DCB-4 DOUBLE DENSITY DISK CONTROLLER

5"/8" CLOCK CHANGE NOTICE

JAMES SPENCER
 1111 DUAL DENSITY CONTROLLER
 SILKSREEN ASSEMBLY
 SHEET 1 OF 1
 DATE 10-9-79
 I.W. No. DCB-4

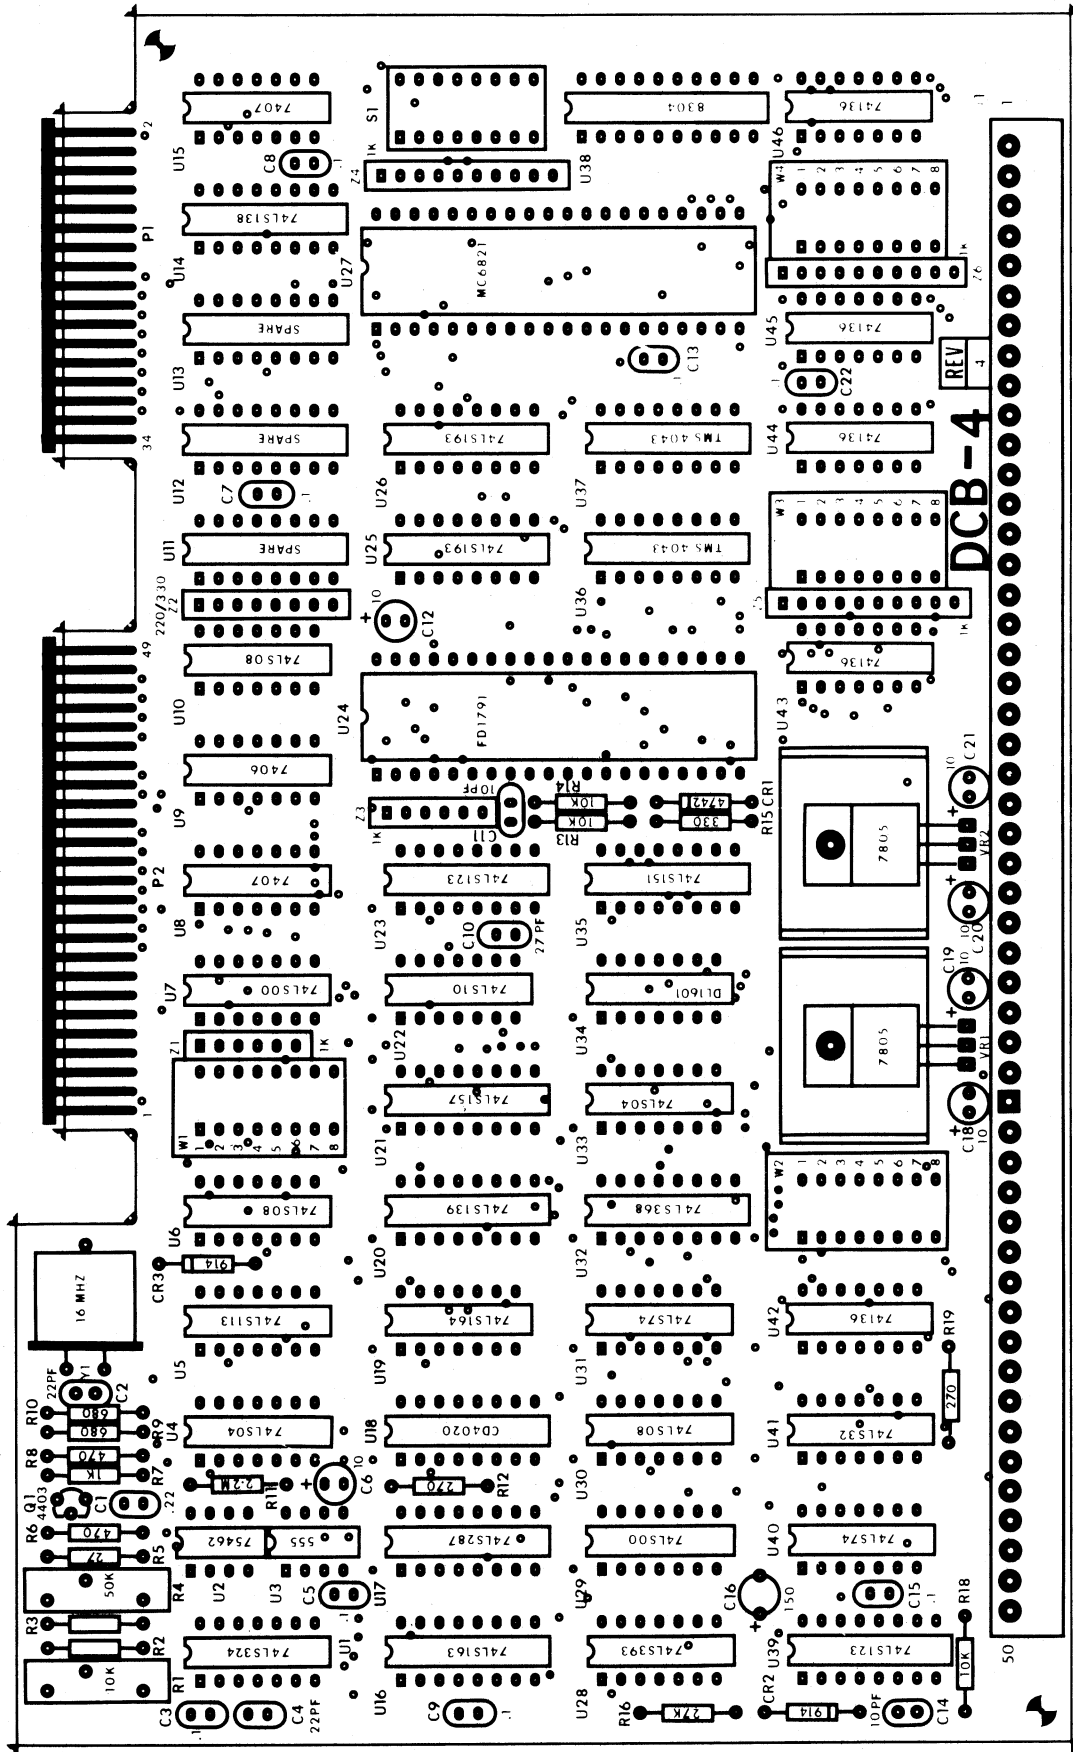
When copying between 5" and 8" disks, the system may occasionally hang up. This is due to an intermittent problem with the 1791 controller chip. If the problem occurs frequently, the following circuit will correct this.

Cut the trace leading from IC U32 pin 5
Cut the trace leading from IC U29 pin 13
Jumper U11 pin 7 and 8 together (puts ground on pin 7)
Add socket to U11 and IC 74LS113
Jumper U11 pin 1 to U29 pin 1
Jumper U11 pin 5 to U29 pin 2
Jumper U11 pin 6 to U29 pin 13
Jumper U11 pin 2 to U32 pin 4
Jumper U11 pin 3 to U32 pin 5
Jumper U11 pin 4 to U11 pin 14
